MEMORANDUM

TO: Cape Elizabeth Planning Board
FROM: Maureen O'Meara, Town Planner
DATE: April 21, 2020
SUBJECT: 287 Ocean House Rd Site Plan

"Sec. 19-6-4(D)(3)(e) Openings. The relationship between doors and windows to exterior wall space of a building creates a rhythm or pattern."

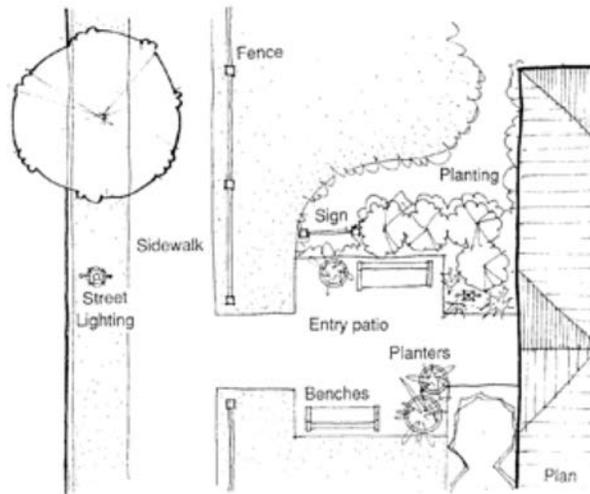
The Town Center design standards also require that "the side yard visible to the public should be designed to present a pleasing appearance to the pedestrian." This leads into a requirement (subsection c. Openings) that "the first floor front facade shall be constructed with an equal proportion of openings to wall space." This standard reflects the Town Center District purpose "to encourage an identifiable Town Center that includes ... an environment inviting to pedestrians..."

One of the most interesting features of the existing building is the mullioned front corner window. The applicant is proposing to replace the window with a new, more energy efficient window. The applicant should consider a window that retains the mullioned look, which is represented in several buildings in the town center, including buildings directly across from the property on Scott Dyer Rd.
